My Ref: BG-296-220826-Rpt26-DRAFT

Glenorchy City Council

REVIEW OF LANDSLIDES FOR GCC
REPORT 26 – 28 August 2022

Figure 1 Critical survey monitoring points (in red) and groundwater monitoring boreholes (in blue). Point 24 circled in green.

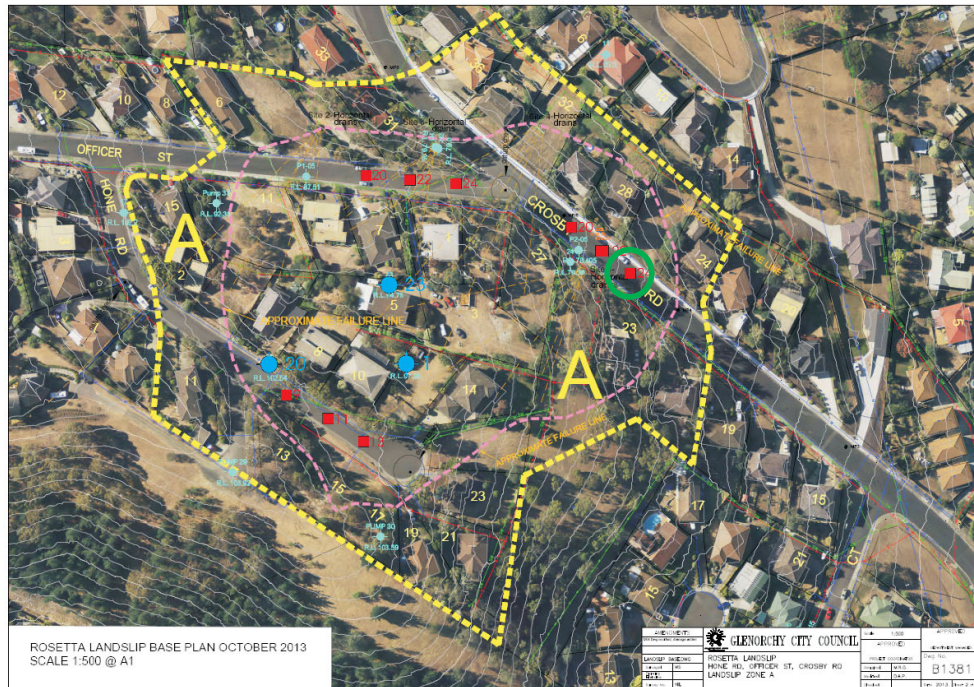
The last survey was in May 2022. There appears to be a long term trend of settlement and lateral displacement of between 10 and 15 mm over the last 10 years in this area with survey point 24 showing possibly 15 to 25 mm settlement over the same period. There is no significant movement of the landslide but these slight ongoing movements that affect Officer Street, particularly those movements around point 24, continue to require careful consideration and are discussed below in Section 4.

The slight ongoing movements that affect Officer Street, particularly those movements around Point 24 (circled in green in Figure 1) have been of minor

concern for some time. Site inspection suggests that these movements result from the proximity to the toe of the landslide and the seepage in the gutter, where further movements are more likely. The observed movements should continue to be monitored and may be reduced by dealing with the seepage issue.

Figure 2 – location of some observations

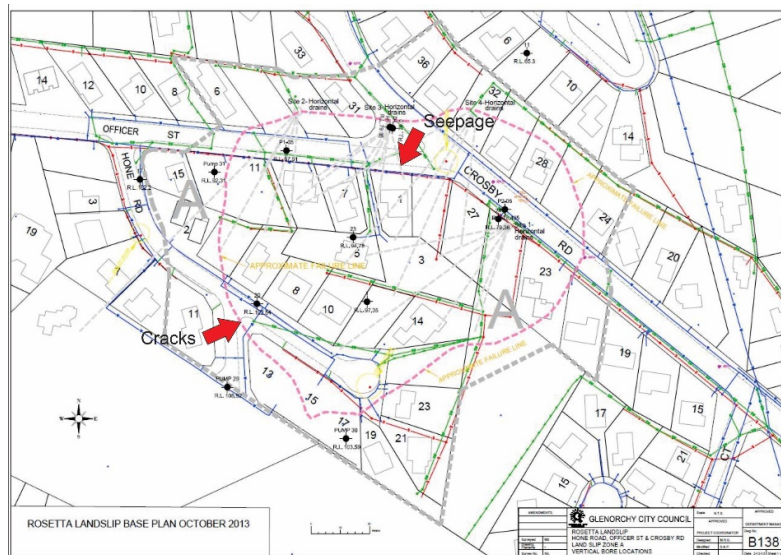
A thorough walk-over survey was carried out at the Rosetta Landslide. Nothing untoward was observed apart from some cracks that needed sealing and some seepage – see Figures 2, 3 and 4 below.

Figure 3 – cracks continuing to open up in the kerb in the cul-de-sac above Hone Rd - see Figure 2 for location.

Figure 4 – seepage in the gutter below No 1 Officer Street – see Figure 2 for location.

1. All significant open cracks in paving and asphalt should be sealed with bitumen during the next maintenance campaign.
2. The source of the seepage in Figure 4 should be investigated – perhaps with a camera inspection of the drain. The aim should be to establish the source of the water seepage and if it is due to an identifiable leak then steps should be taken to prevent further leakage.

Figure 5 Interpreted groundwater conditions before and after drainage

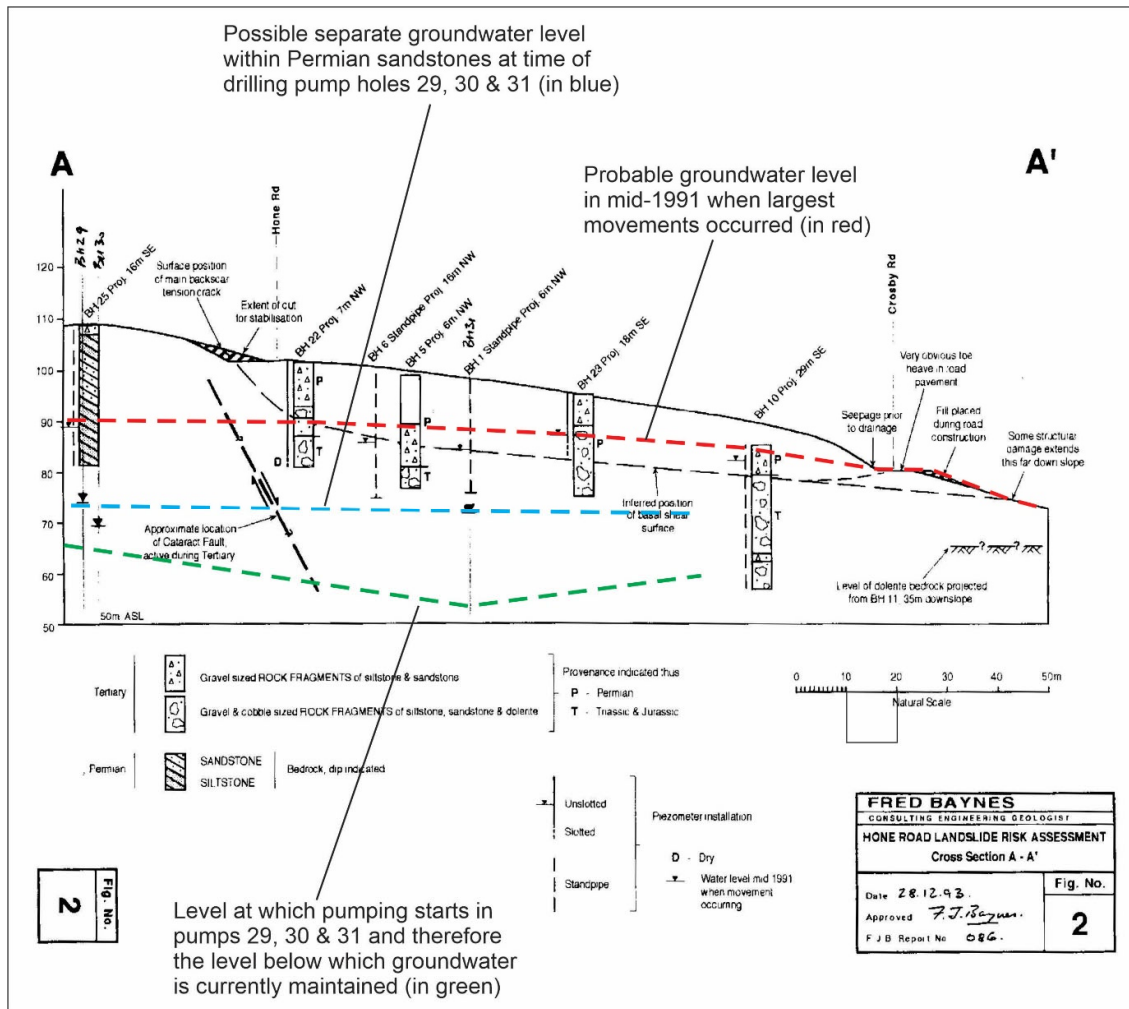
Although there are several boreholes, installed piezometers and around 30 years of records, there is limited detailed understanding regarding the geological and groundwater conditions within the landslide. The following tentative interpretation is suggested:

- There is an upper perched water table within the landslide mass above a less permeable clay rich basal shear plane in the Tertiary sediments
- There is a lower water table within the Permian sandstones and Jurassic dolerites possible connected to the lower parts of the Tertiary sediments
- There is a flow of groundwater from a recharge area to the north-west (in the upper parts of Officer Street) into the landslide area which results in the higher groundwater levels in pump 31.

This suggests that if pumps 29 and 30 were to be switched off a water level rise to around RL 80 is likely and this could reduce the volume of drained ground below the landslide and thus reduce the capacity of the area to safely absorb rainfall events. If pump 31 were to be switched off this would have a similar effect and in addition a water level rise to, say, above RL 86.6 could significantly affect the stability of the landslide. This action is therefore not recommended.

- 1 Pumps 29, 30 and 31 and their associated top and bottom sensors should be maintained at their present levels and continue to be operated for the foreseeable future, or,
- 2 As for 1 but with the top sensor for pump 31 raised to 30 m below the collar level (i.e. at RL 62.2) so that pump 31 does slightly less work.
